## Interpreting The Secretary of the Interior's Standards for Rehabilitation

### Subject: Modifying Historic Interior Railings to Meet Building Code

May 2007, ITS Number 46

*Left: Sample installation of railing modification first proposed did not meet the Secretary's Standards.*

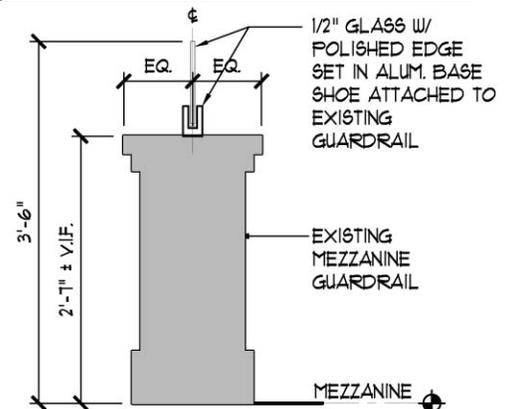
**Application 1** (*Incompatible treatment revised to meet the Standards*): The interior of a circa 1900 bank building featured this very elaborate stair railing. The railing initially proposed to comply with code requirements was too obtrusive and negatively impacted the delicate detailing of the historic railing.

Accordingly, a more compatible (and more refined) supplemental railing was designed consisting of only two, much thinner rails supported by posts capped with finials. The revised design meets the Standards.

*Right: Revised railing that better relates to historic design and meets the Standards.*
